WATERFORD SCHOOL
SPORTS FIELD AND
PARKING

WATERFORD SCHOOL PARKING ADDITION

WATERFORD SCHOOL
STUDENT COMMONS

BUILDING ELEVATIONS

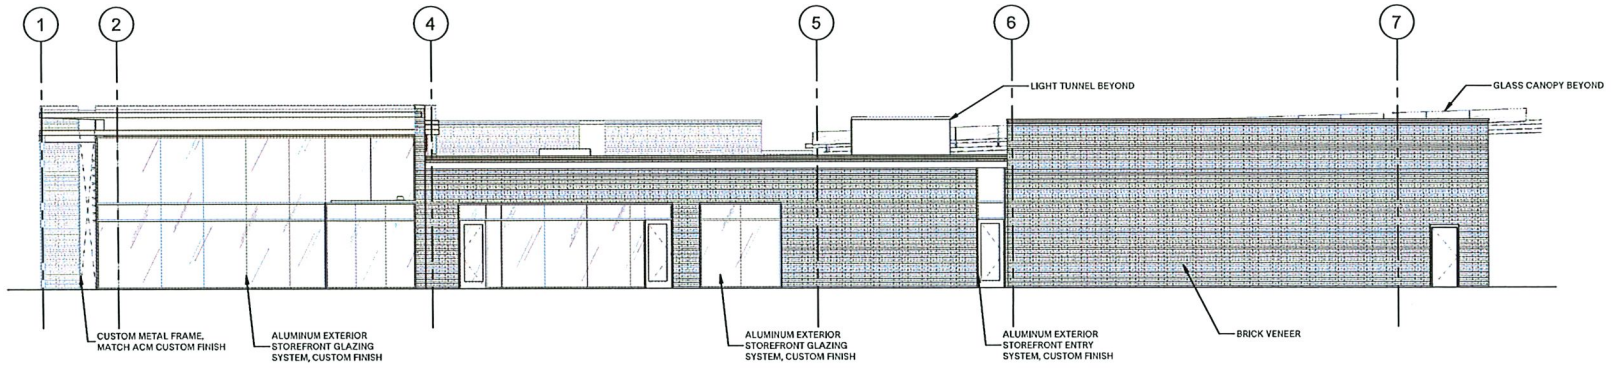
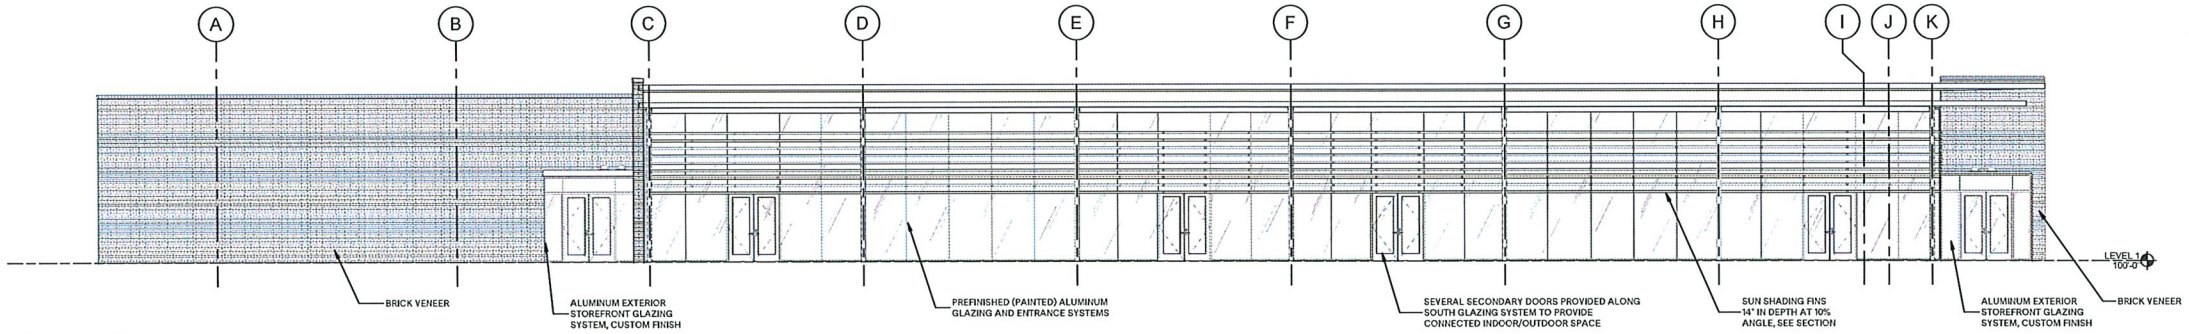
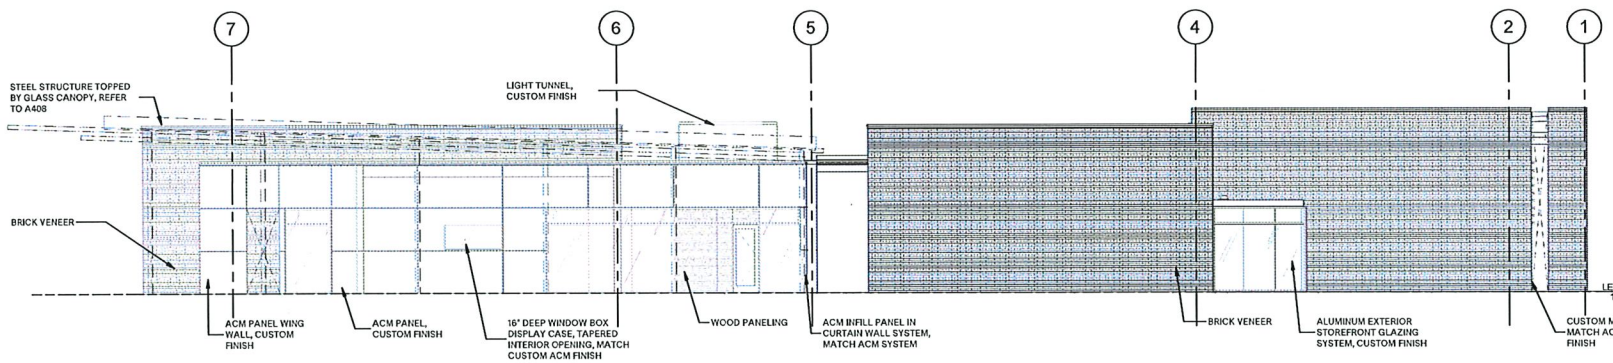
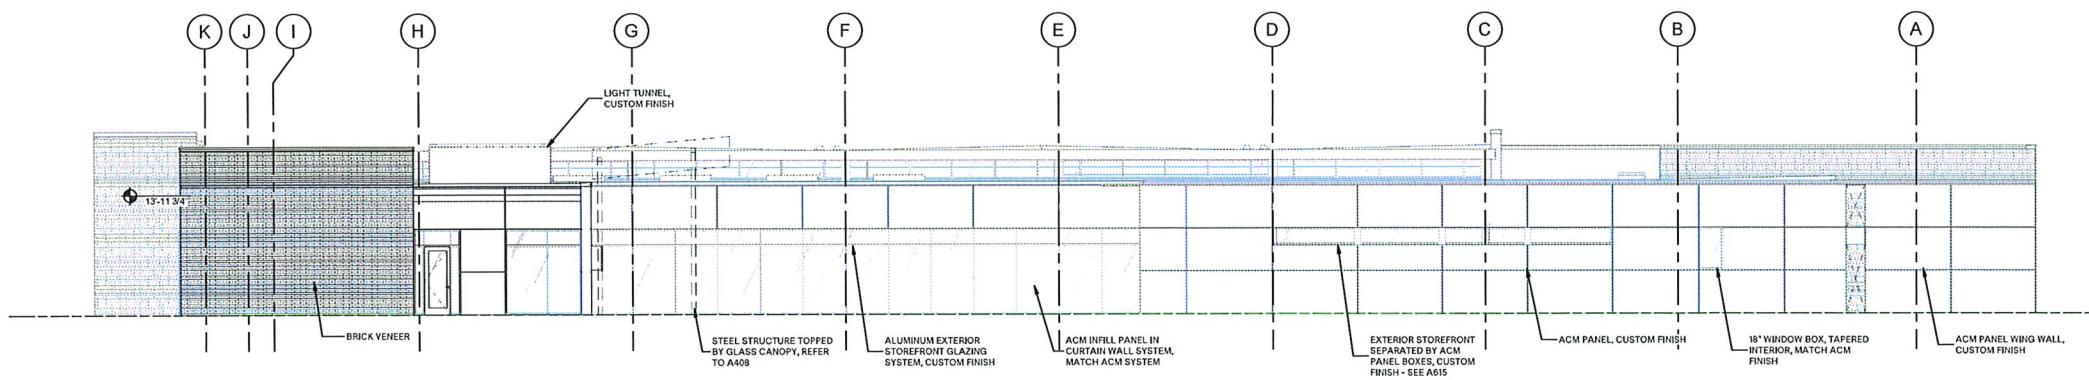
Please show RTU's dashed in behind the parapet on building elevations and colored renderings.

SITE PLAN

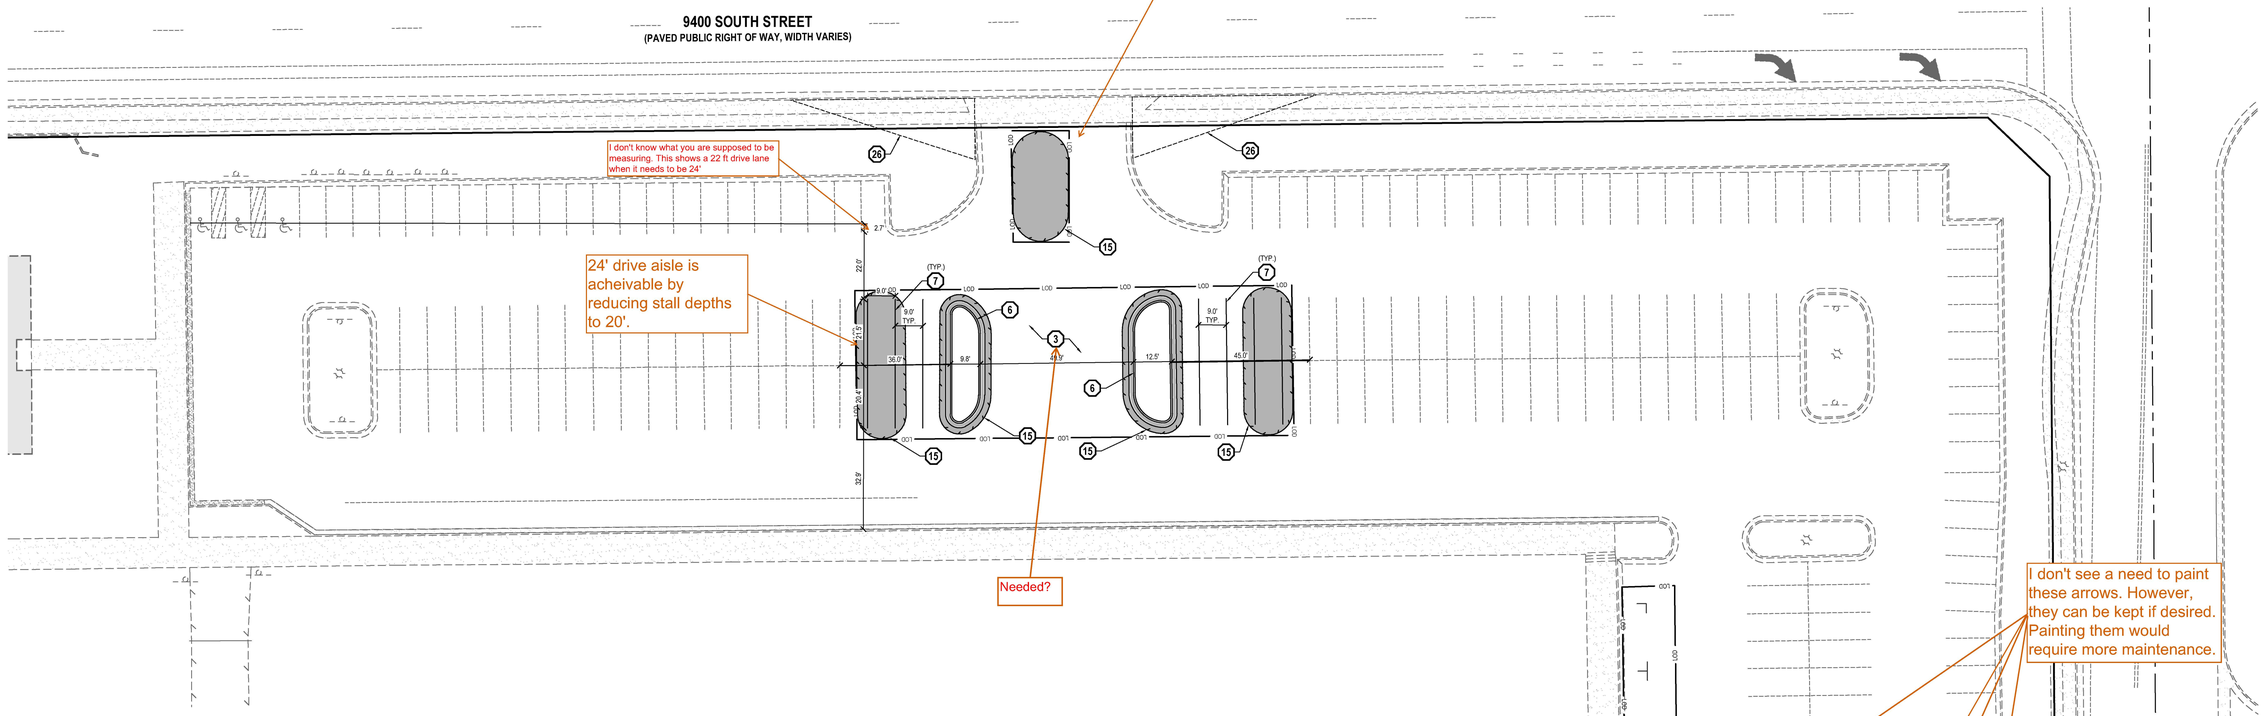
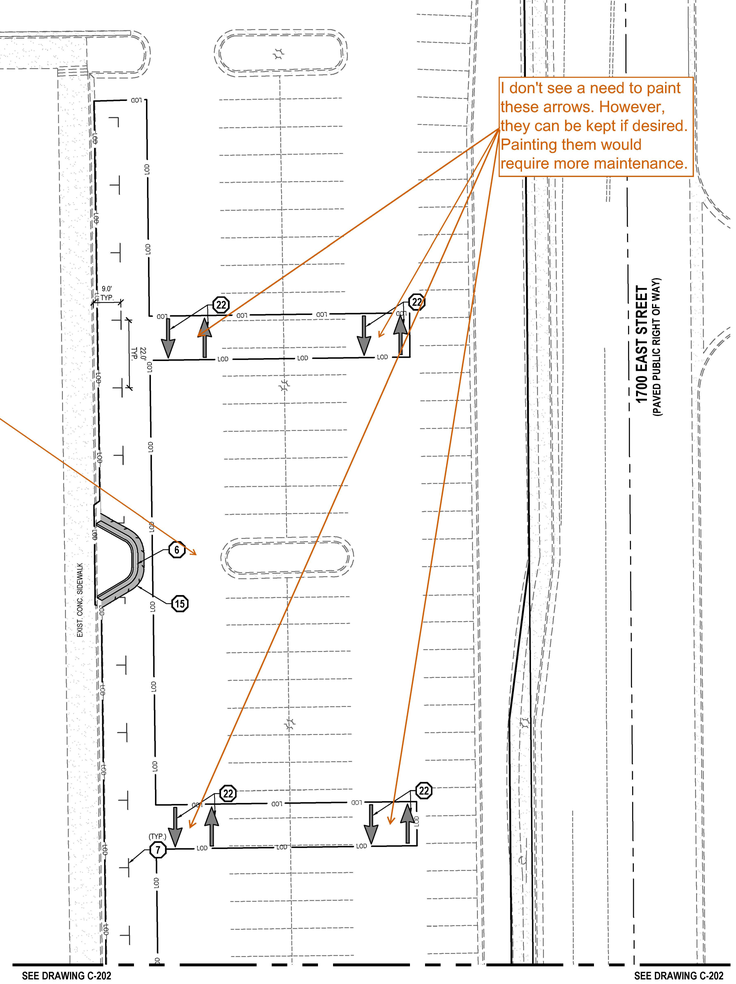
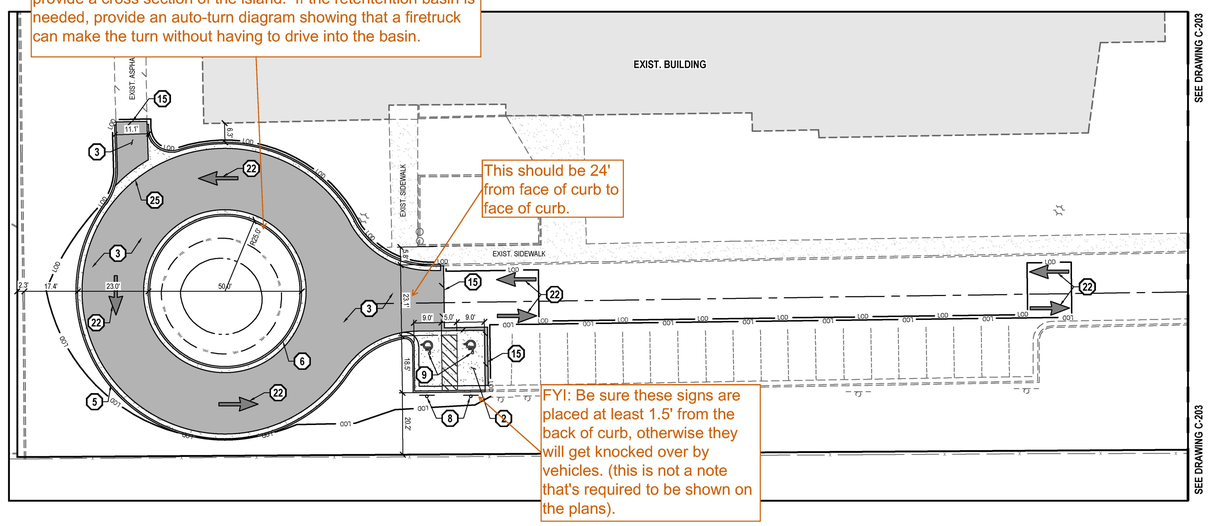
I don't see a need to paint these arrows. However, they can be kept if desired. Painting them would require more maintenance.

Show drive aisle width.

This needs to be a mountable curb and drive-able apron so that large vehicles (fire, garbage, delivery) can drive over it and onto the apron. See our standard detail drawing CG-01. Also, provide a cross section of the island. If the retentention basin is needed, provide an auto-turn diagram showing that a firetruck can make the turn without having to drive into the basin.

This should be 24' from face of curb to face of curb.

FYI: Be sure these signs are placed at least 1.5' from the back of curb, otherwise they will get knocked over by vehicles. (this is not a note that's required to be shown on the plans).

GRADING AND
DRAINAGE PLAN

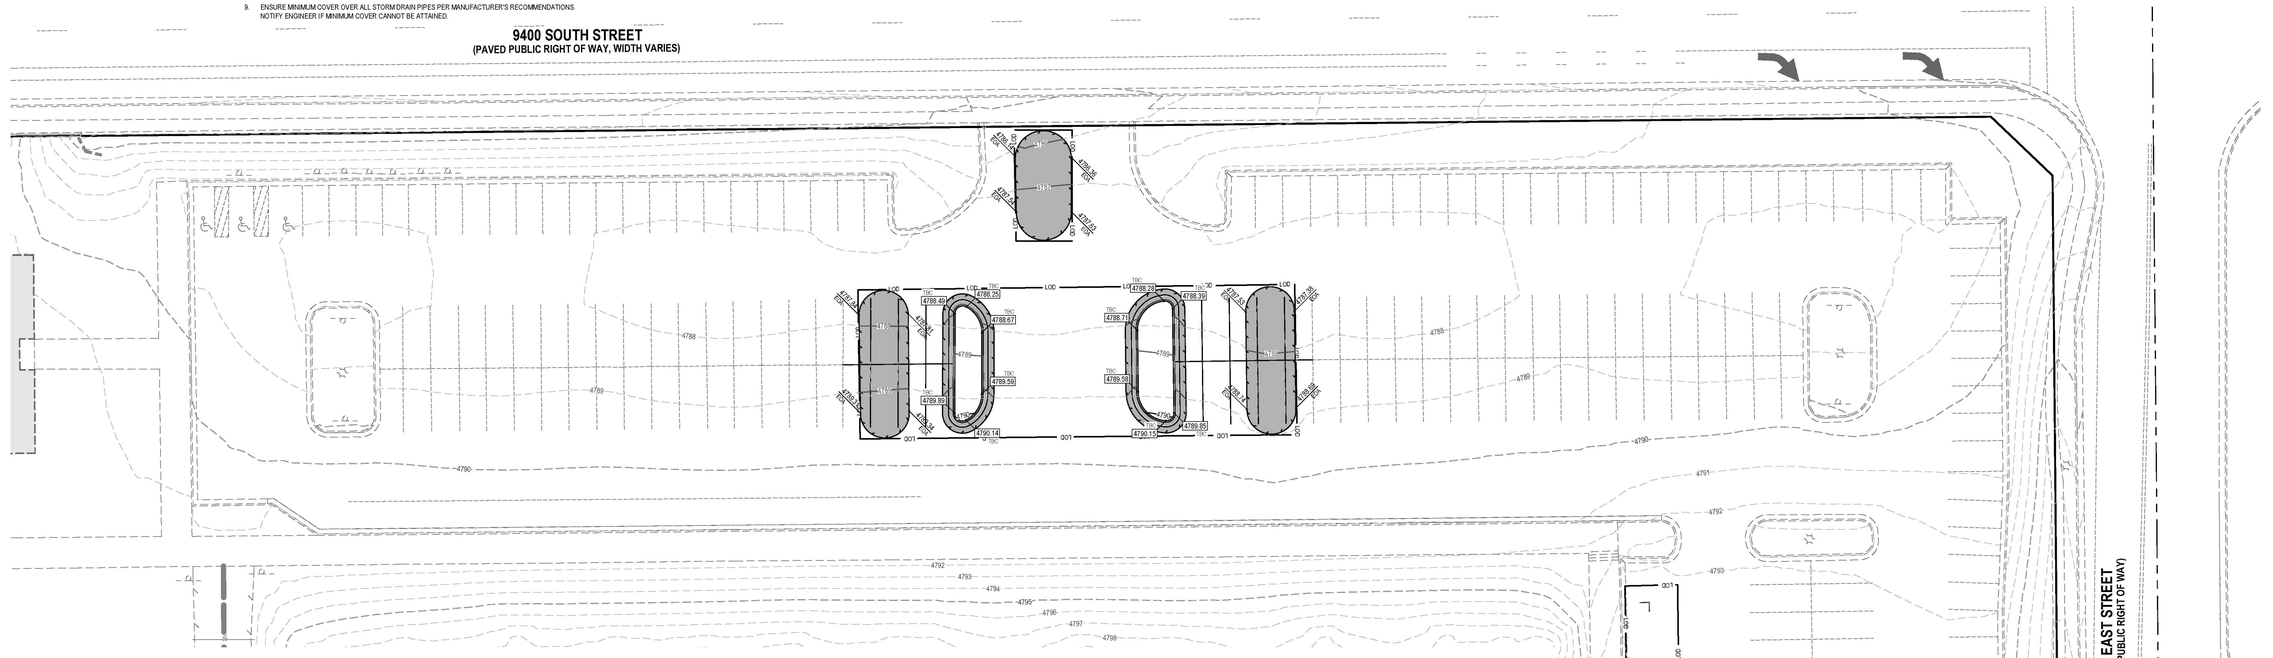
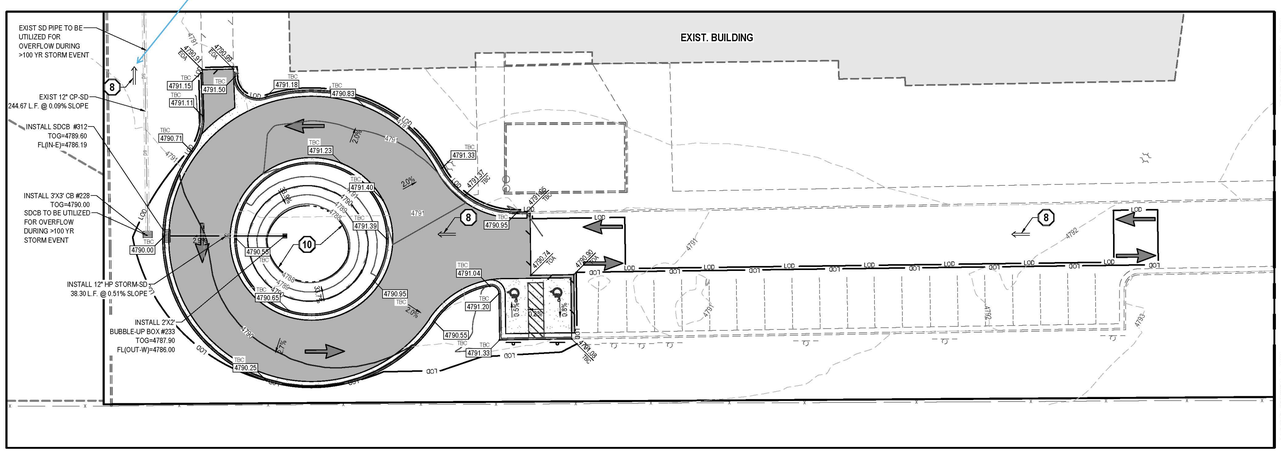
Need to show existing storm drainage system.

Is this going to be a ponding issue? Add some existing grades outside the LOD to show flows will not stop. Typical on all tie in locations for the grading plan.

Missing spot elevation

GRADING AND DRAINAGE PLAN

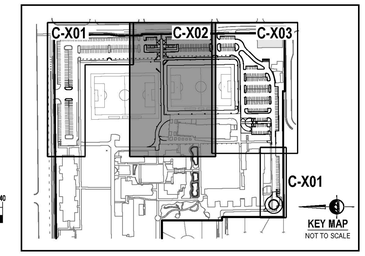
Add existing spot elevations at all points that are tie in.

Add slope call here.

GRADING AND DRAINAGE PLAN

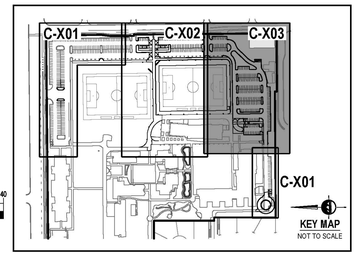
Add TBC

Doesn't look like a high point or ridge line. Verify spot elevation

Add long. slope

How does this grade away from building? Show more detail/elevations.
